## TECH NOTE

# INSTALLATION RECOMMENDATIONS FOR TIMING BELT SYSTEM ON HONDA 1.7L ENGINES

**BULLETIN:** TSB008\_AU

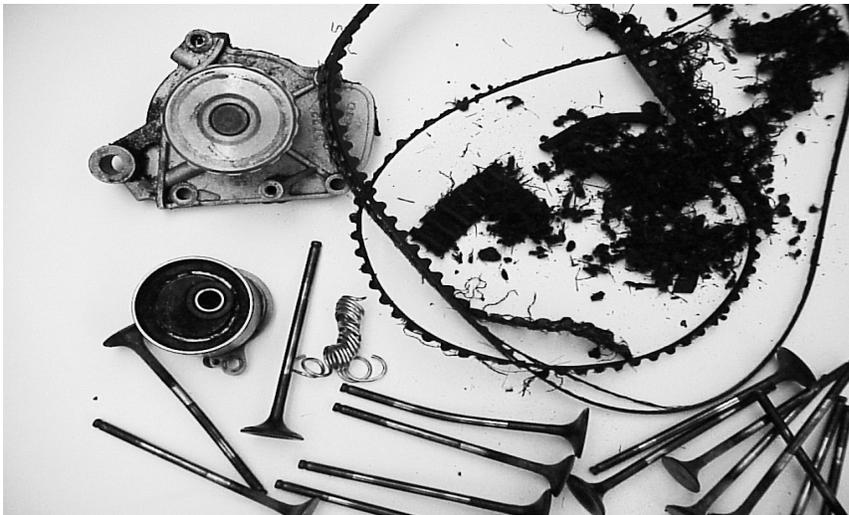
Below is the result from improper belt setup. Notice the damaged spring, this is the result of turning the crankshaft clockwise during initial setup, which is incorrect.

Crankshaft must be rotated two turns **COUNTERCLOCKWISE** with locking pin in tensioner and attachment bolt loose. Not following proper installation procedures will cause:

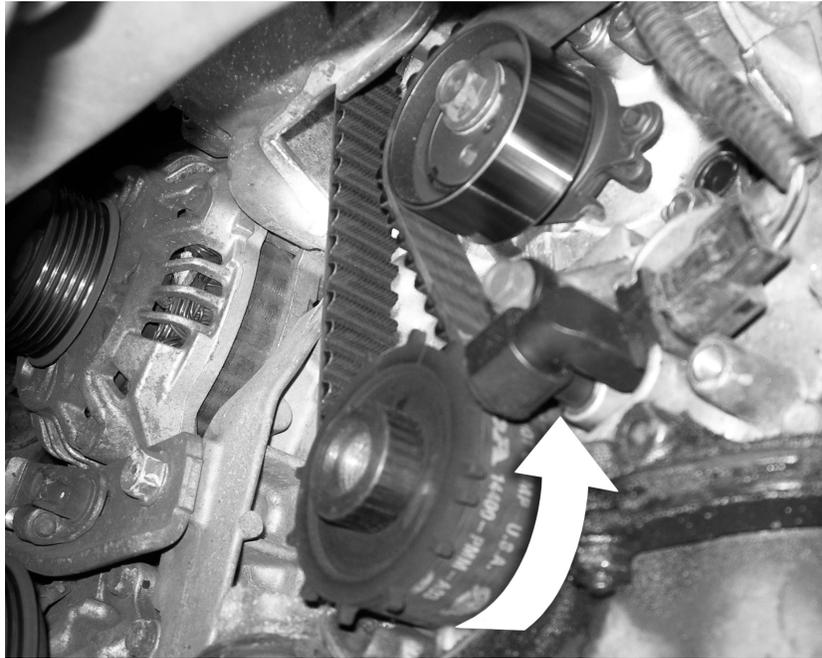
During setup attention needs to be given to the relationship of tensioner spring. The spring must be in the “UP” position which is noted on the spring rubber dampener.

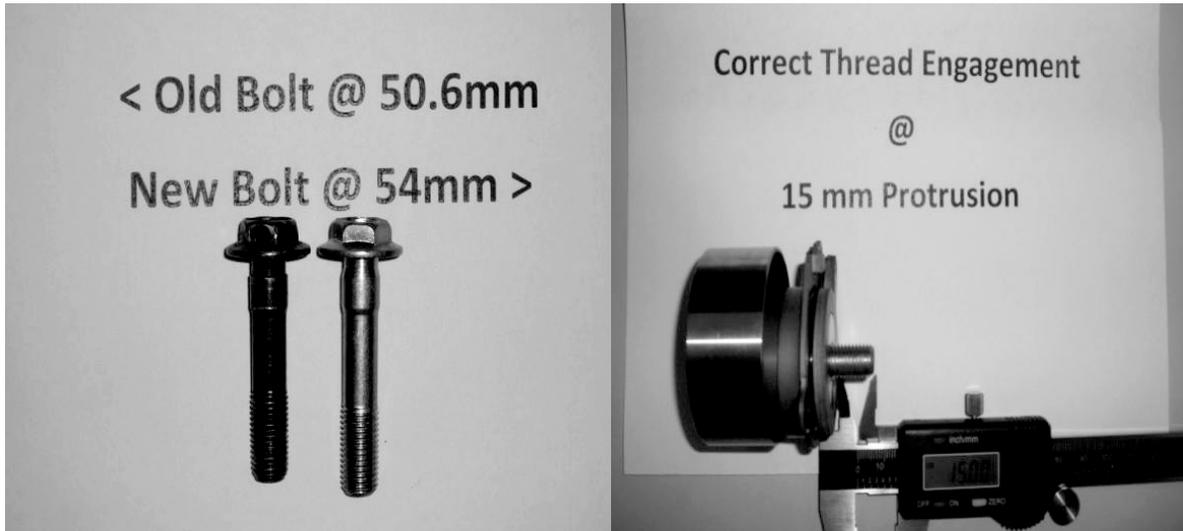
### **2001 – 2003 model years may require a longer fastening bolt!**

Please be advised that early model year Civics may require an updated tensioner bolt. Honda upgraded the timing belt tensioner assembly in late 2002. Gates Tensioner follows the design change. During this change the OE bolt length was also changed to allow for proper thread engagement. Gates supplies the updated bolt as part of TCK312 Kits.

Verify this issue with one of the following procedures, the updated OE tensioner and bolt has been provided in this kit.

1. With tensioner fastening bolt placed through tensioner assembly – Verify there is 15mm of thread engagement.
2. Measure Bolt: Bolt length for new tensioner design provided in this kit should be 54mm in length.

(Incorrect Bolt Length Is 50.6mm).
